Bulletin No.: 50141-15045A
Updated: October 2017

PRODUCT SAFETY RECALL

SUBJECT: Takata Front Passenger Air Bag Module Assembly Replacement

MODELS: 2006 Saab 9-2X

Twisting the Tool and Releasing Center Claw

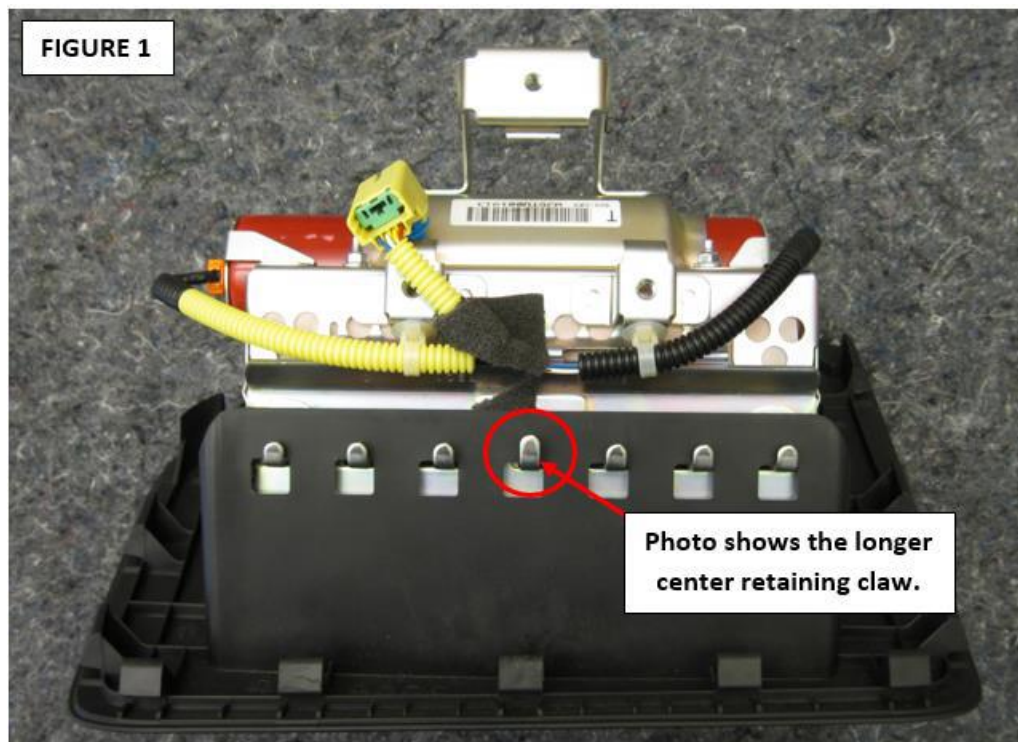
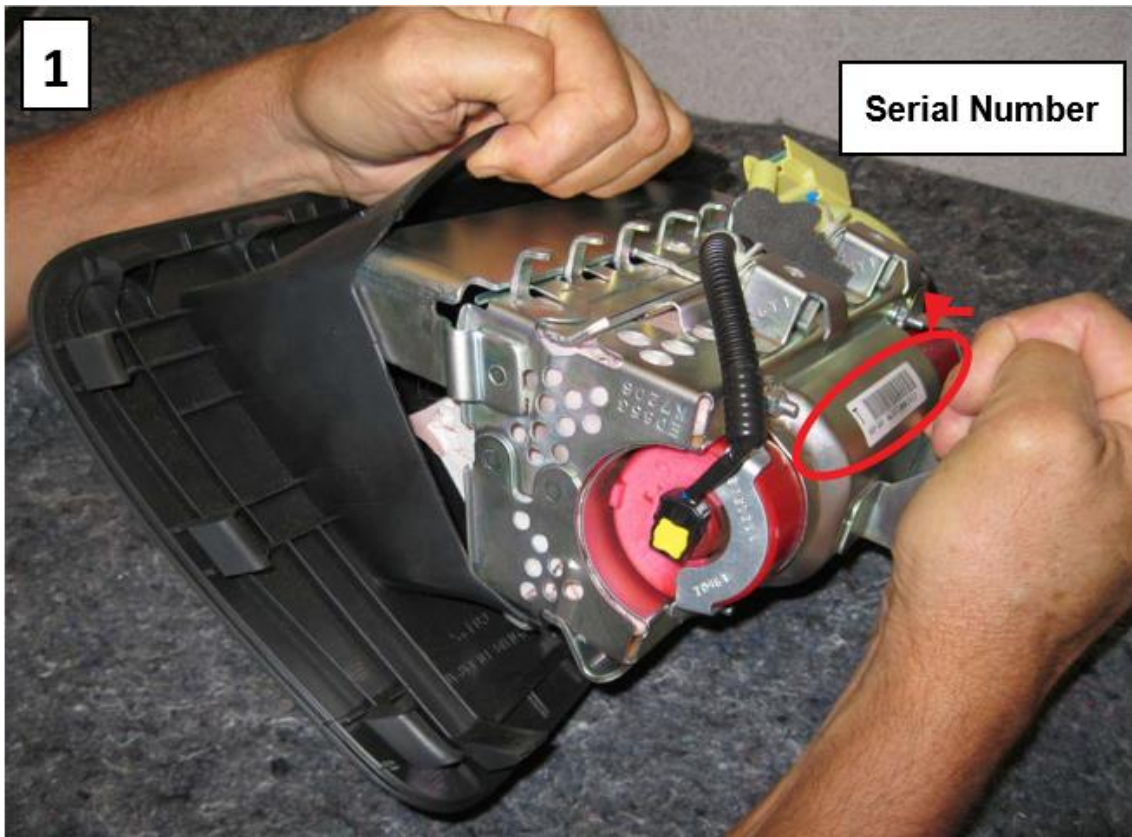
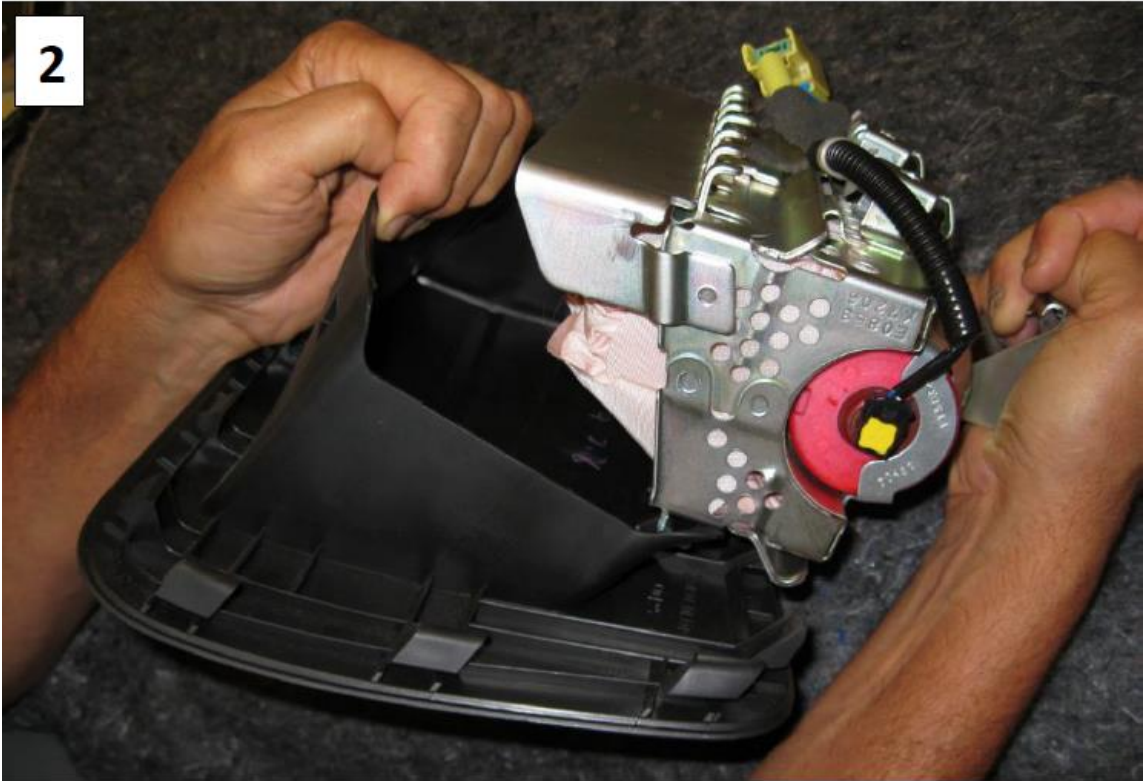
- Using a trim clip removal tool and starting on the harness-side of the module assembly as shown in photos and sequence below, **CAREFULLY** insert the tool and twist **ONLY AS MUCH AS IS REQUIRED** to release the slightly longer center retaining claw from the trim cover. Once released with the tool, the other 6 claws will release easily by hand.
- Rotate the inflator portion of the assembly outward from the cover to release the 7 label-side claws and separate the cover from the module. No tool is required as all the 7 label-side claws are the same size.

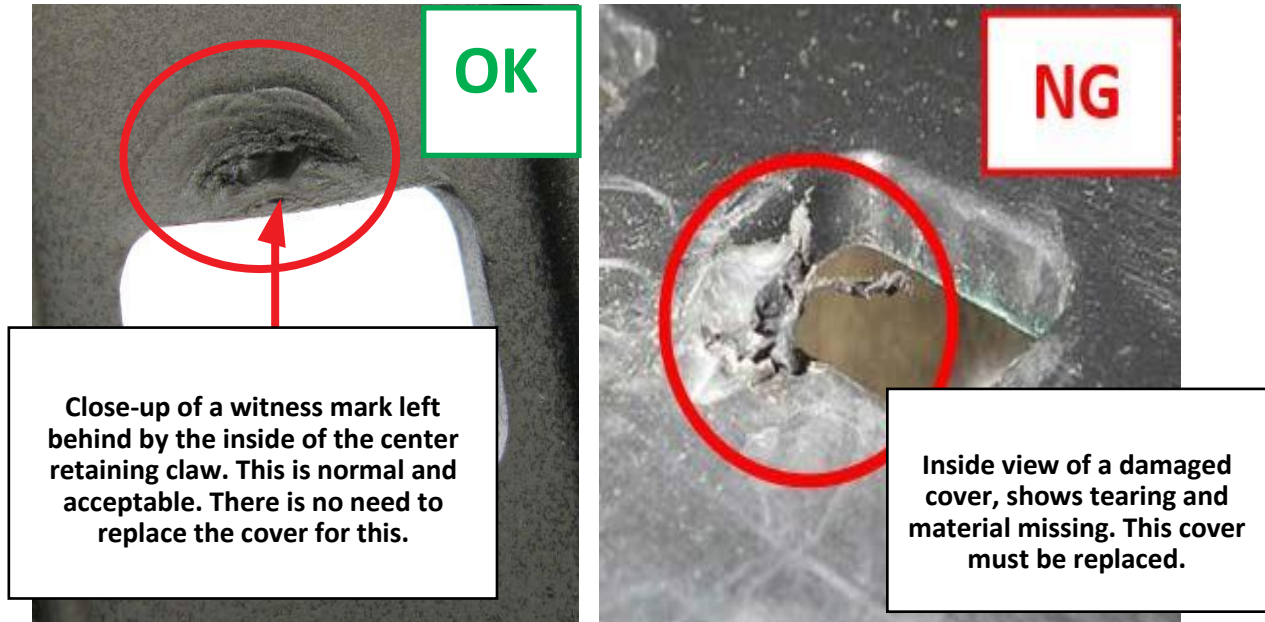
- Once all the harness-side retaining claws are released (EASILY done once the center claw is released), CAREFULLY separate the inflator module from the cover. After the harness-side of the module is free from the cover (2), simply rotate it to unhook the label-side retaining claws. Remove the cover completely as shown in (3) below.
